EL MONTE UNION HIGH SCHOOL DISTRICT

April 14, 2023

TO : All Bidders
FROM : El Monte Union High School District
BID # : 2022-23(B8)
PROJECT : Mountain View HS Modernization Project
SUBJECT : Addendum No. 2

1. LPA Architects Addendum No. A issued April 14, 2023 attached.

MK-2.11

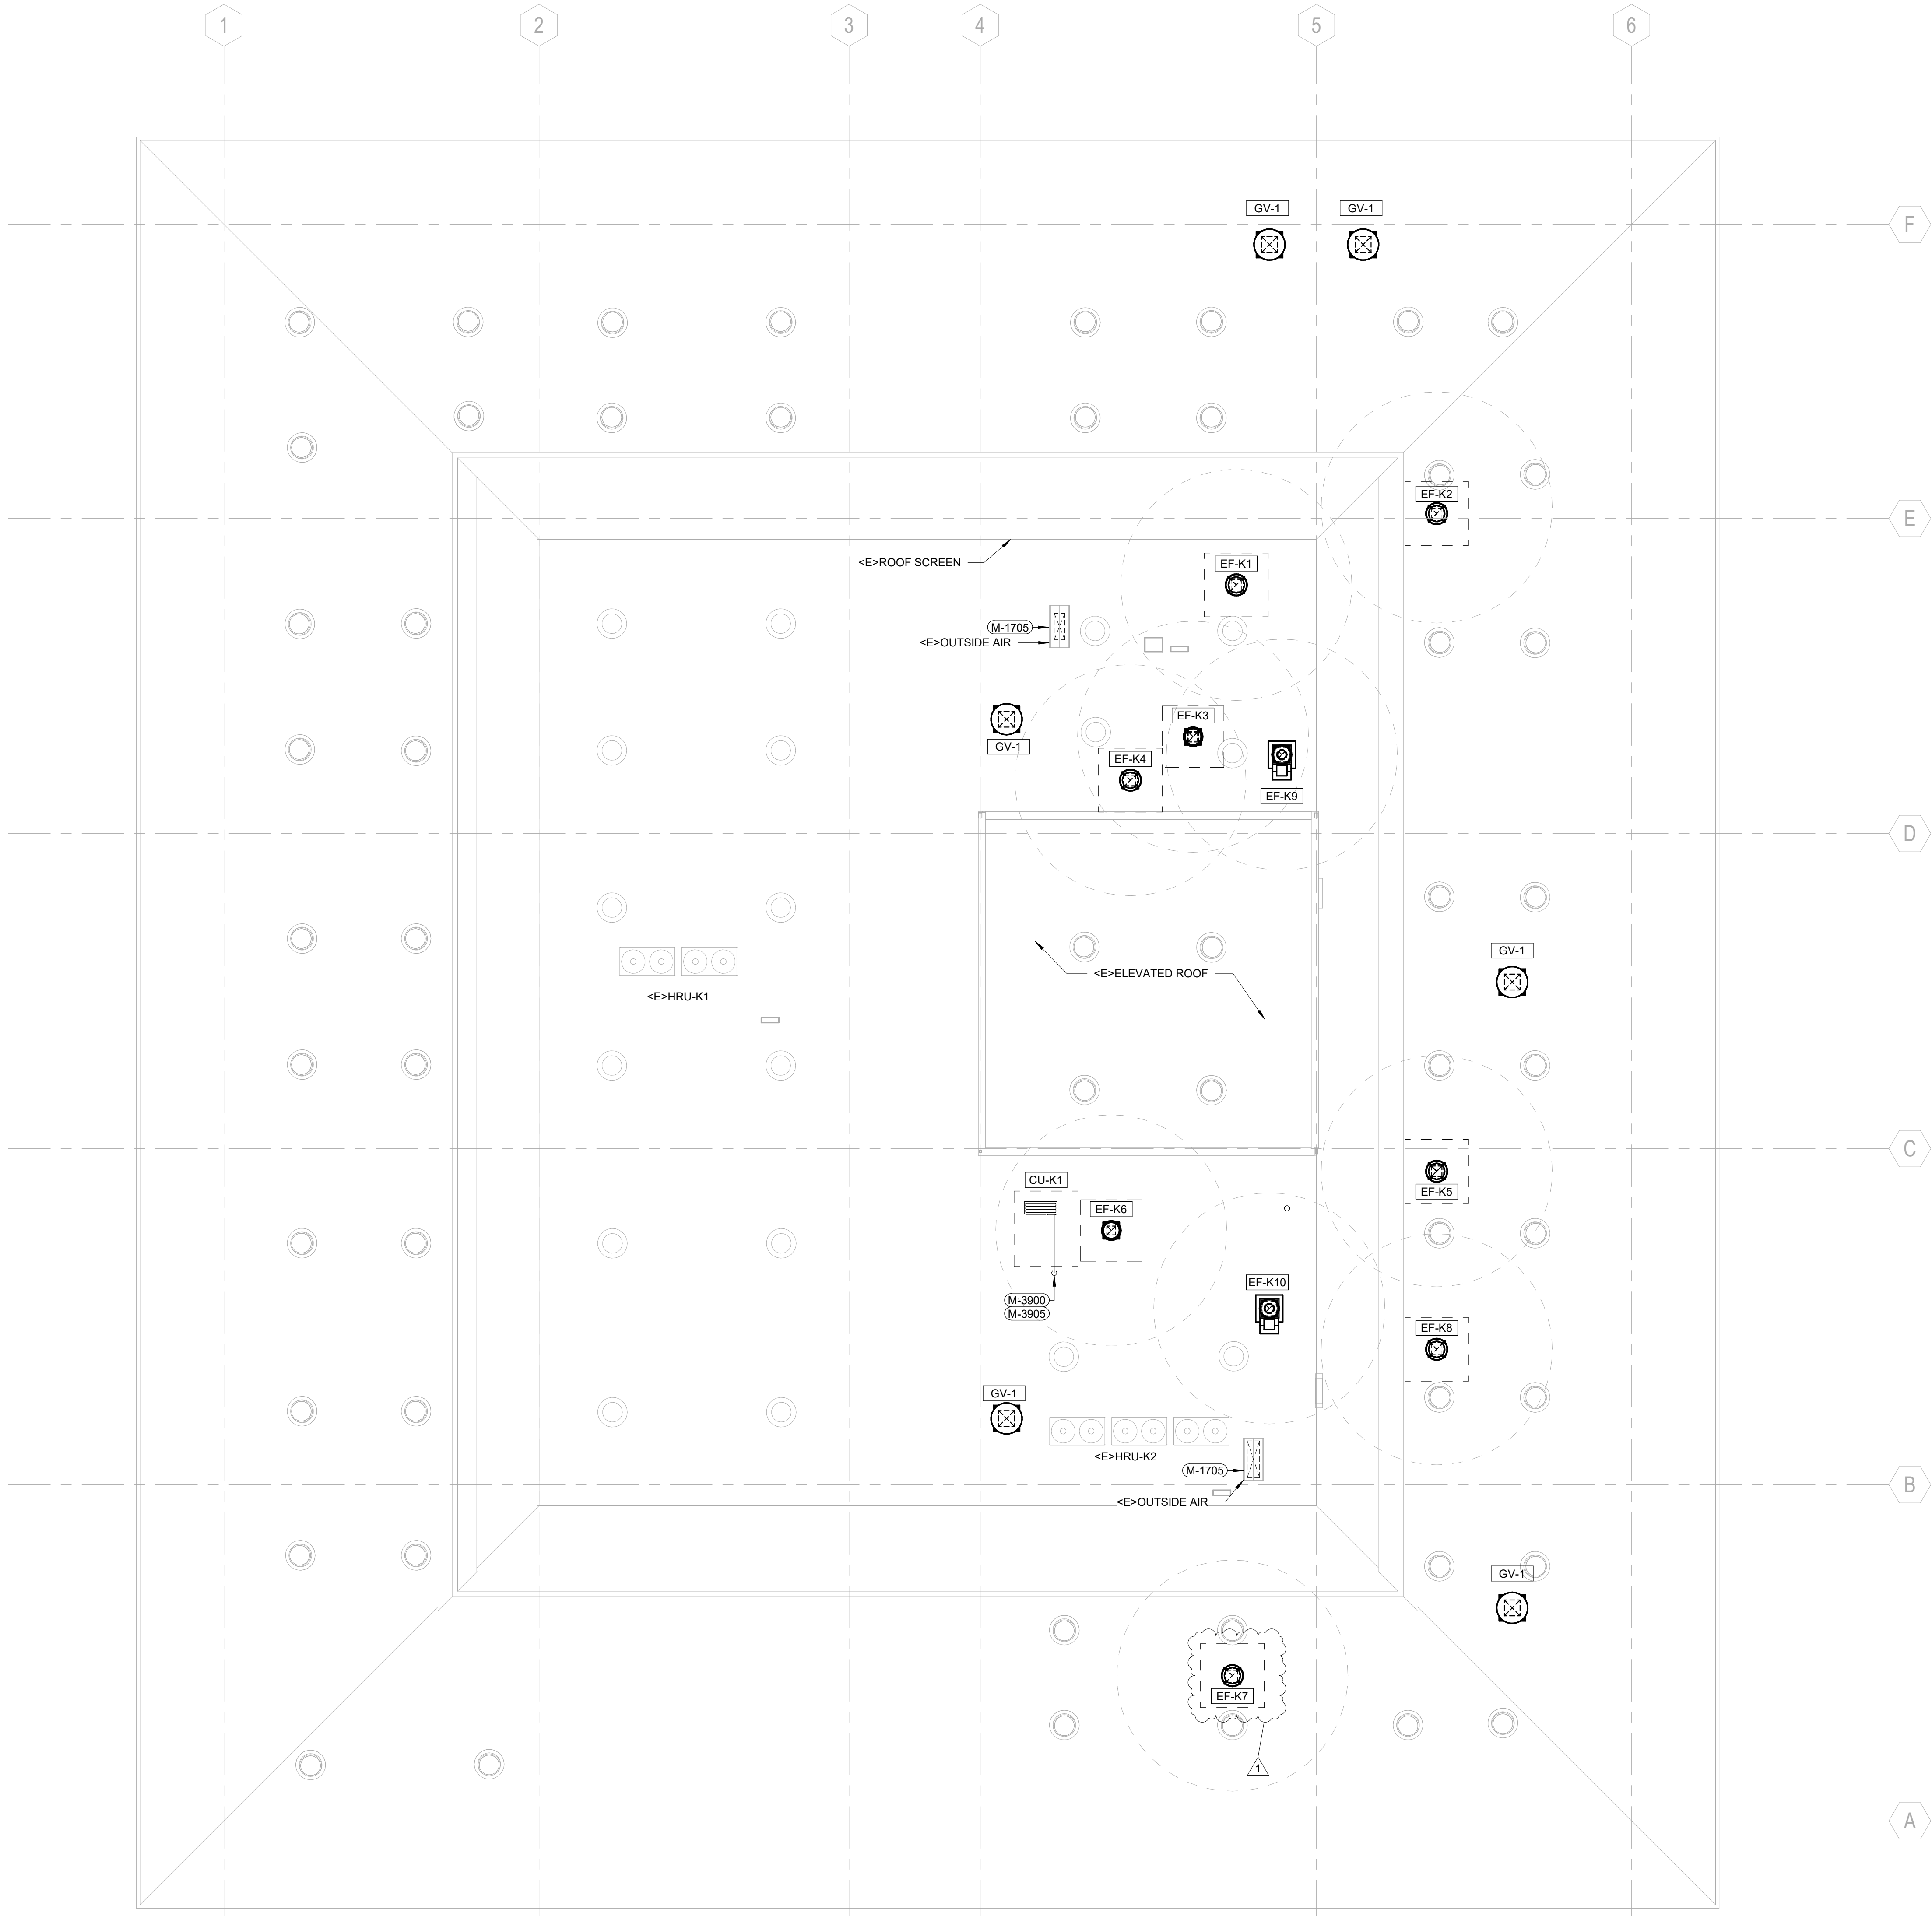
- Item No. 40** **Sheet MK-2.11 – Mechanical Floor Plan**
(a) Shifted EF-7 drop south
(b) Rerouted EF-7 ductwork to avoid solatube conflicts

LIGHTING FIXTURE SCHEDULE

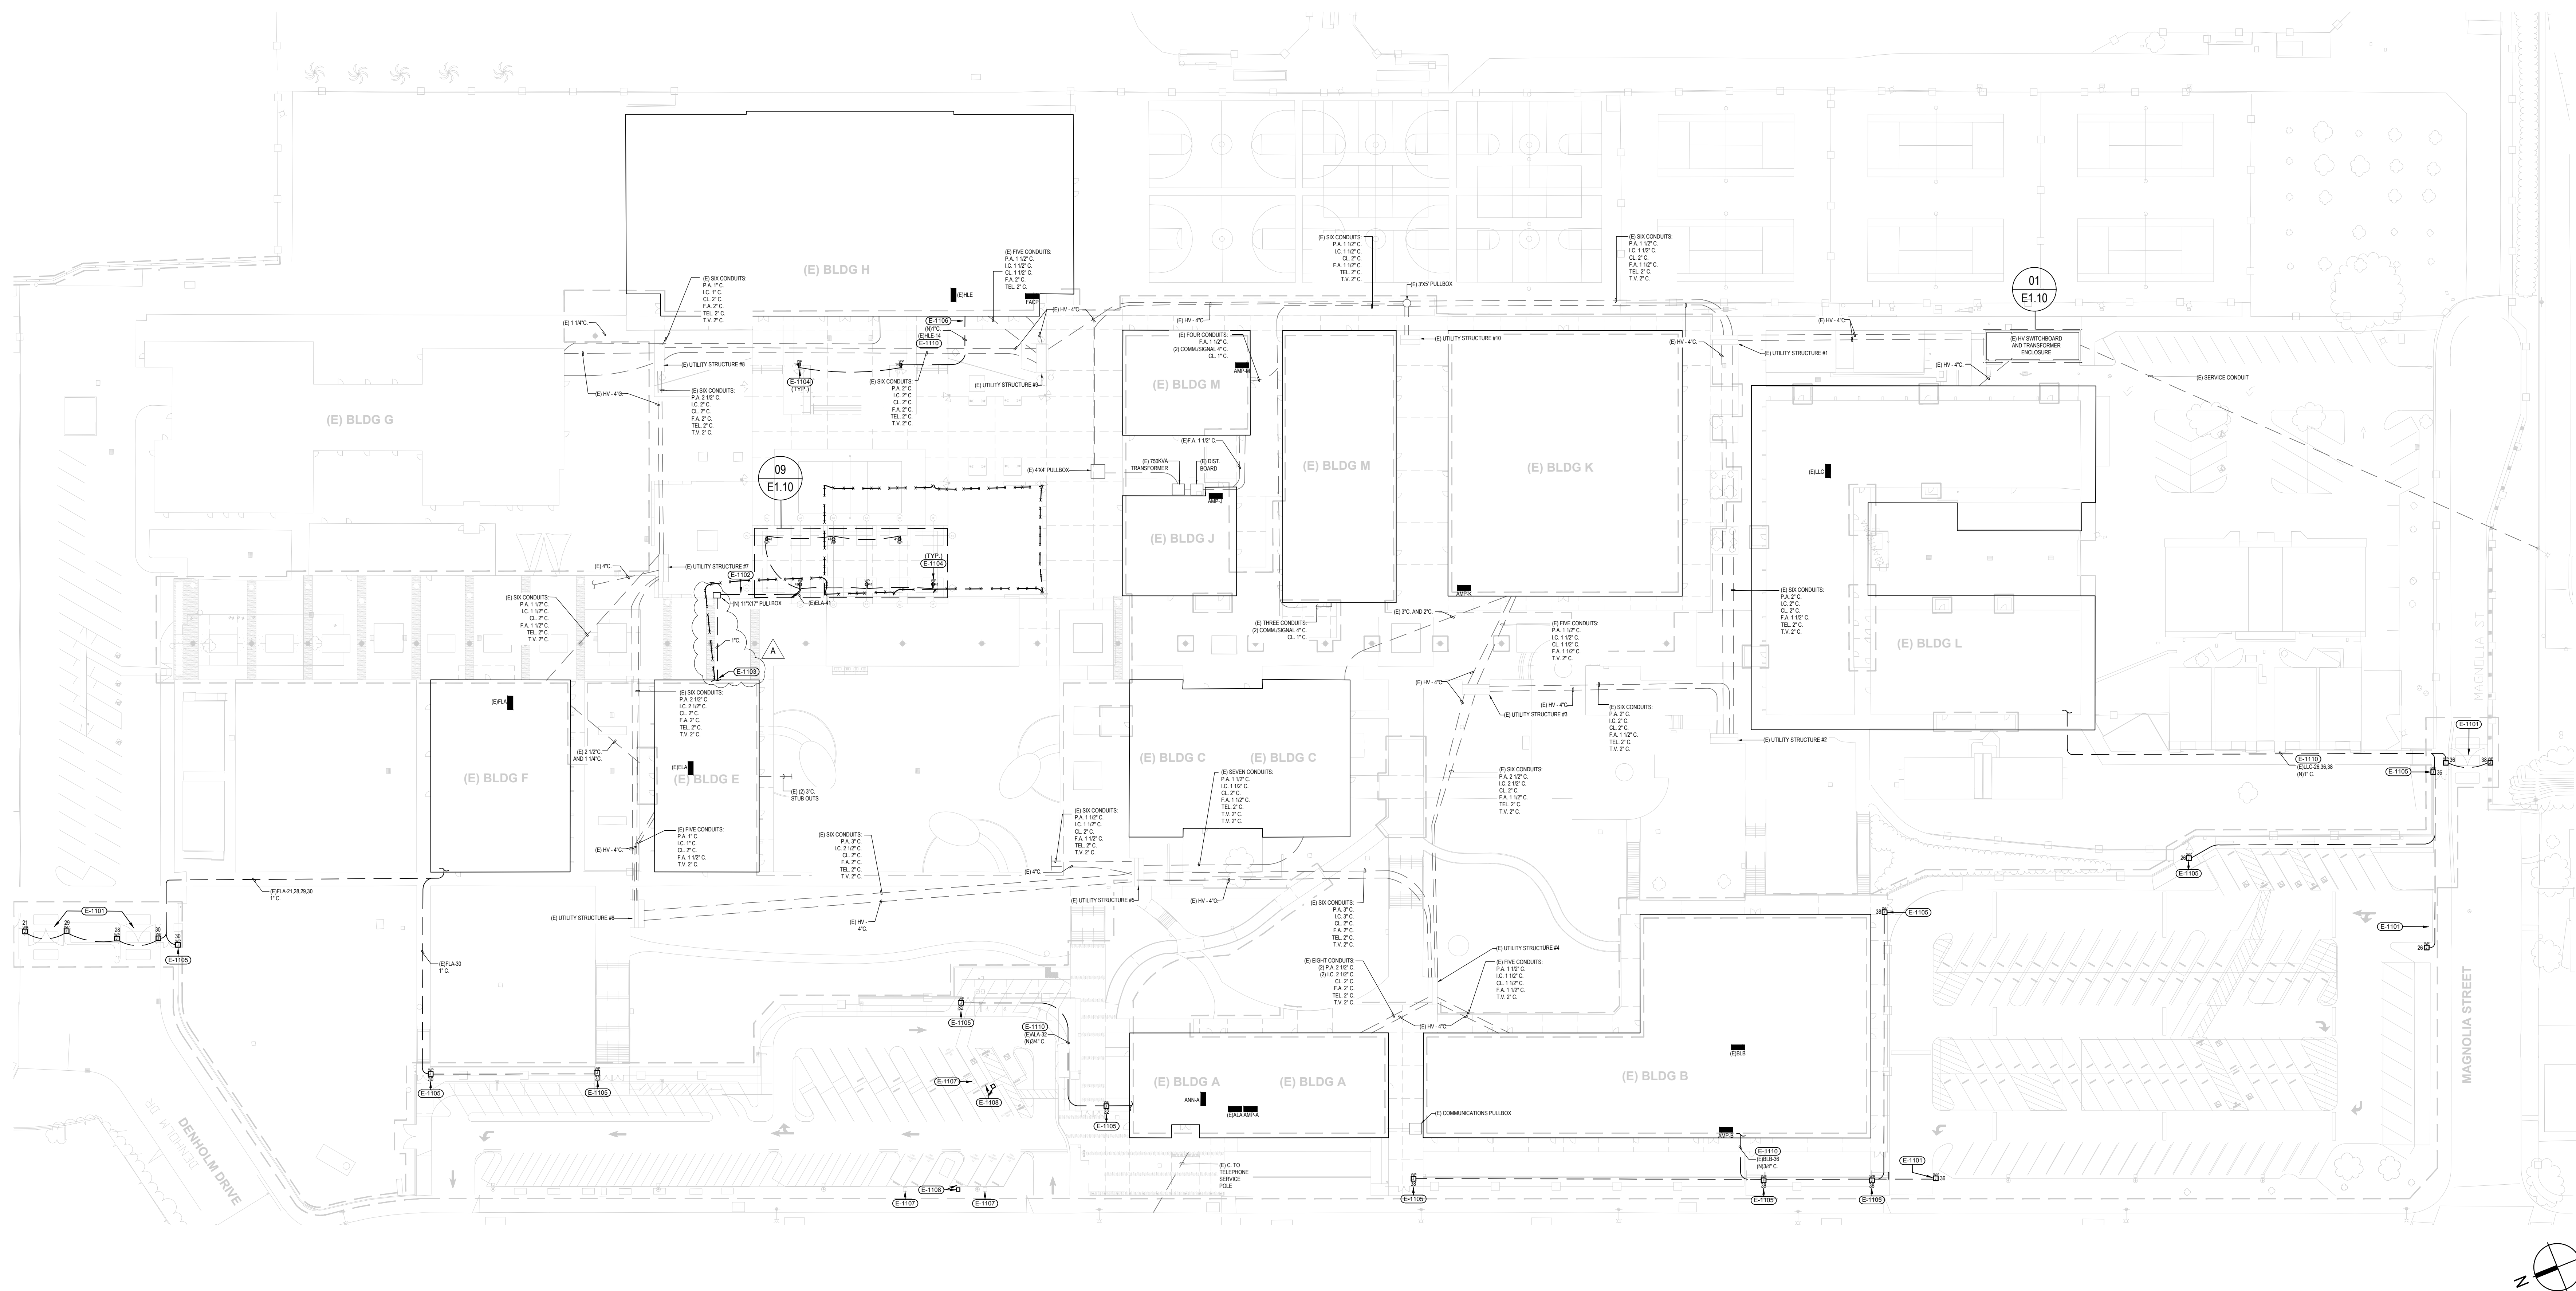
- Item No. 43** **Sheet E0.21 – LIGHTING FIXTURE SCHEDULE**
(a) Clarified type mark for type “ZN2-T5B” poles. (No change in product).

E1.10

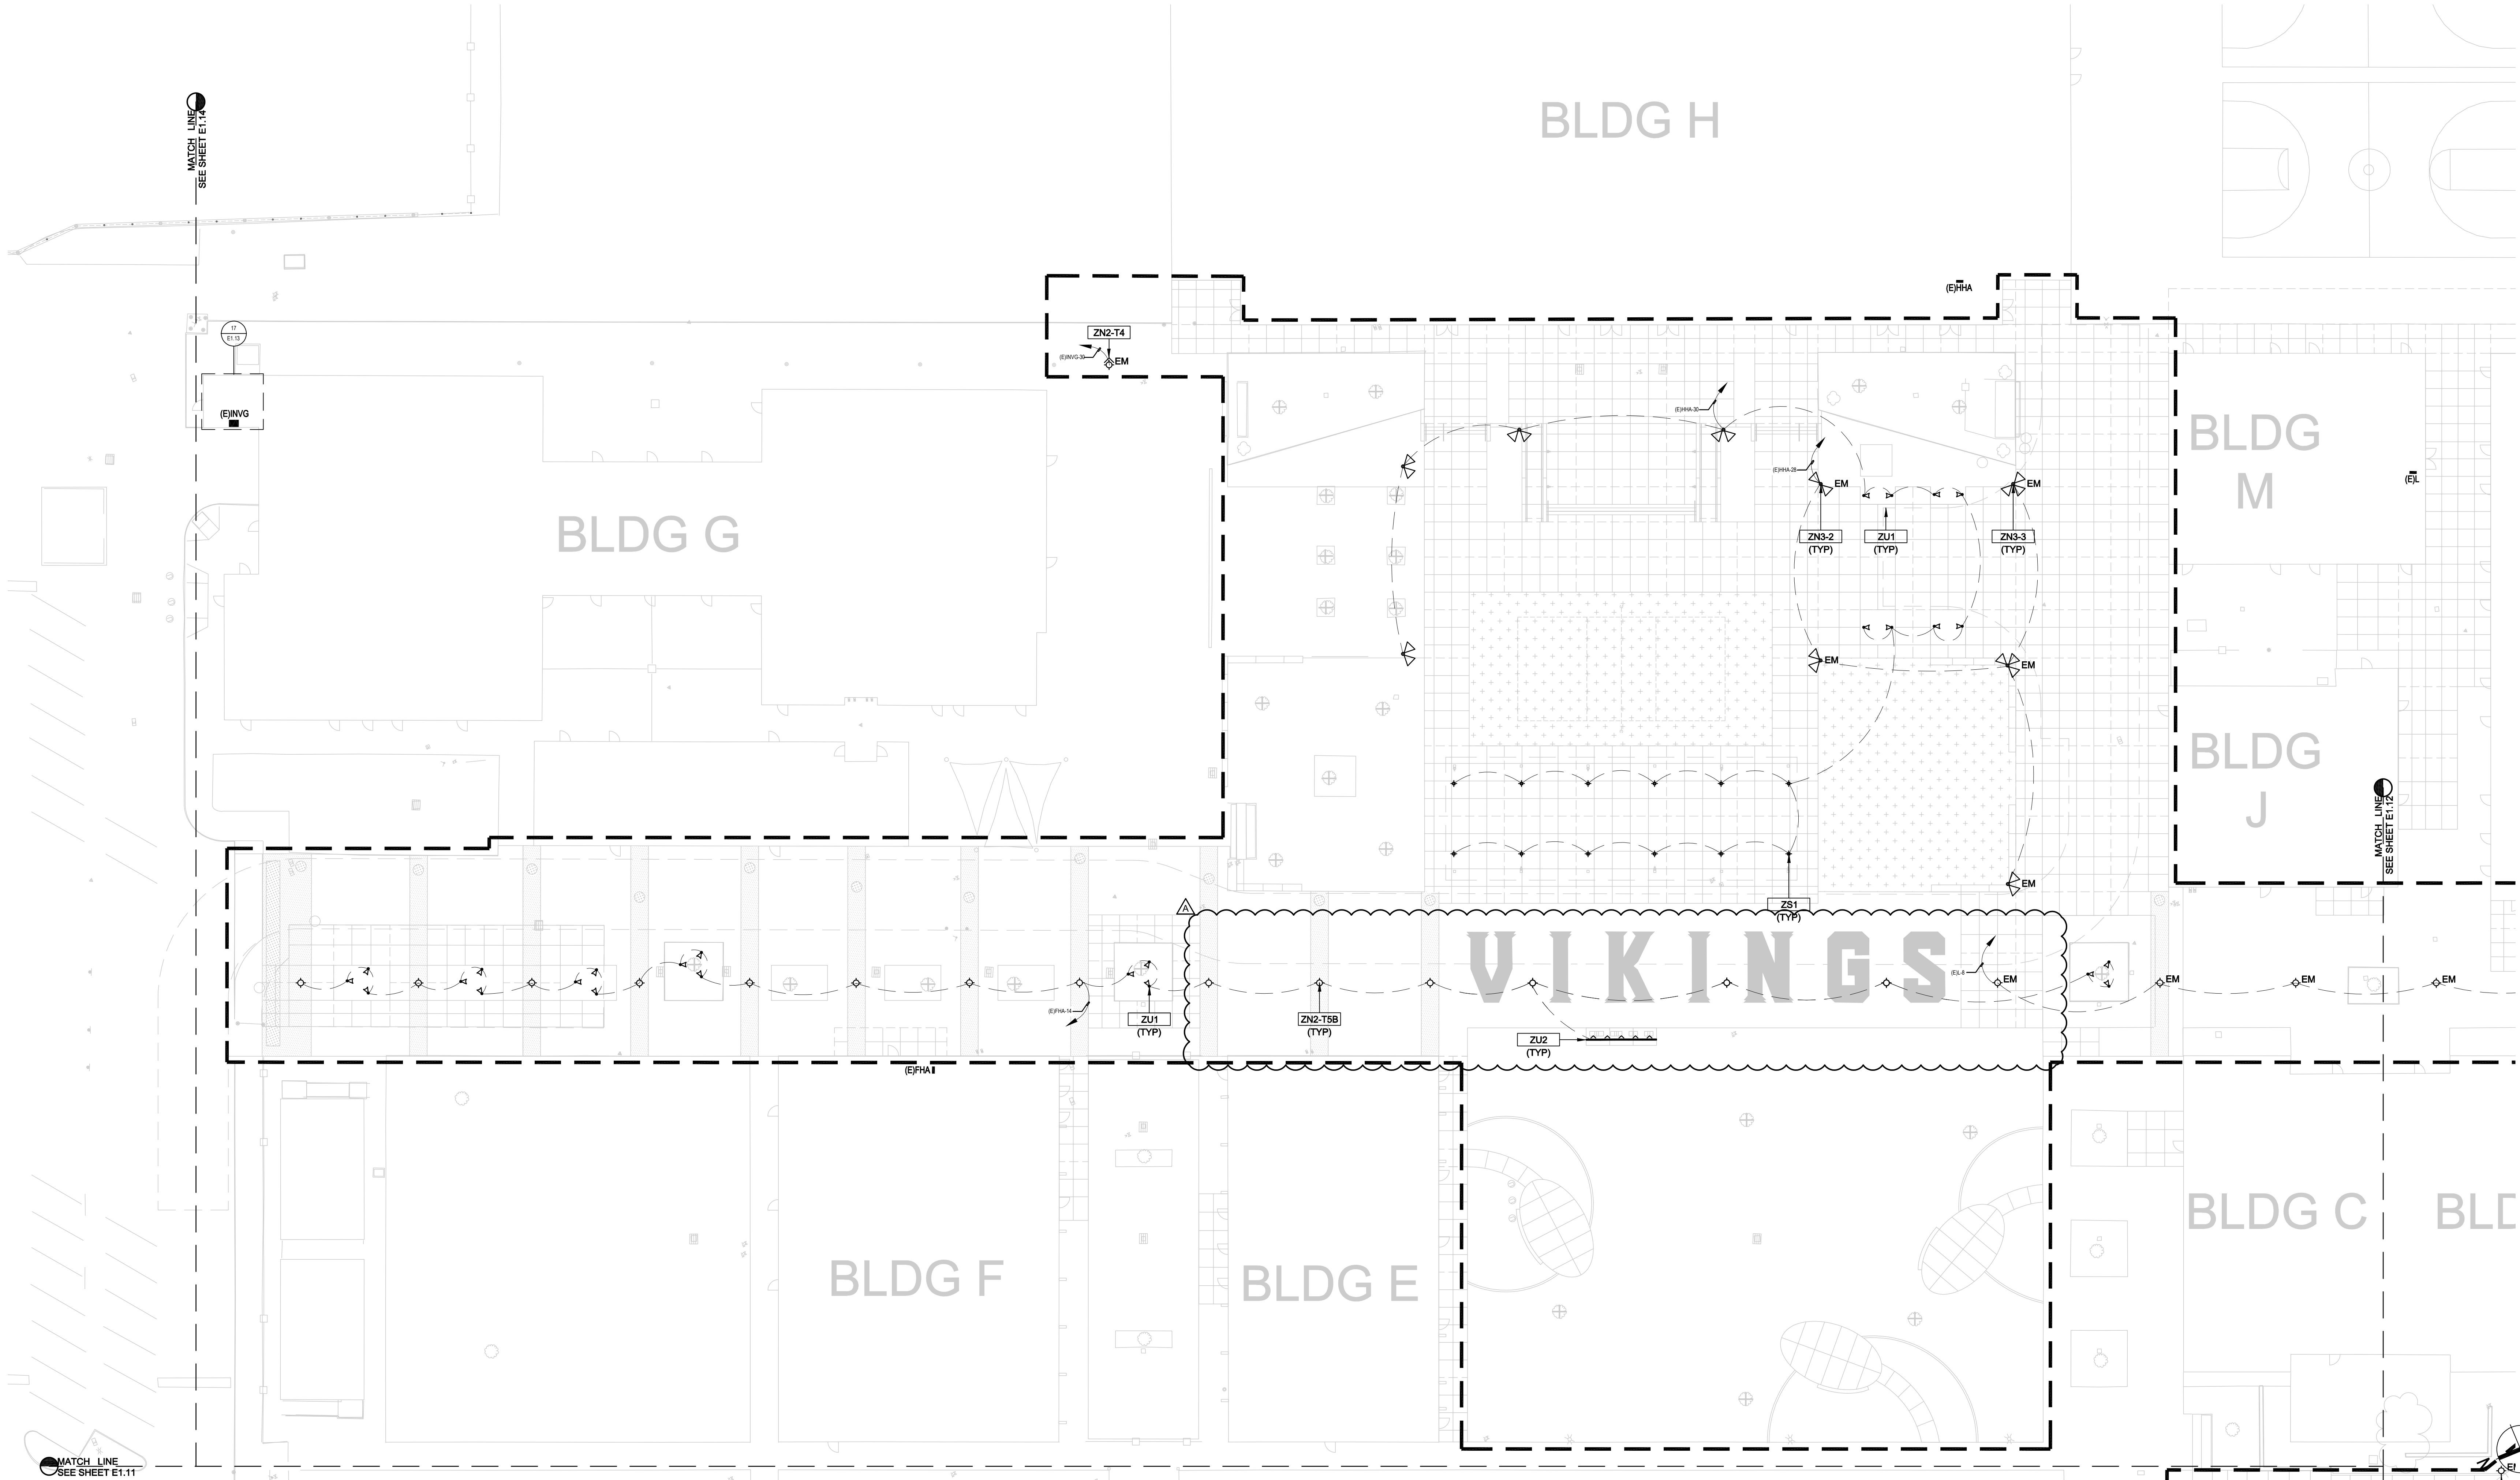
- Item No. 42** **Sheet E1.10 – ELECTRICAL SITE PLAN**
(a) Updated conduit routing from building E feeding the lunch shelter. Existing conduit routing out of building E to be demoed.
(b) Updated keynotes E-1102, E-1103, and E-1104.
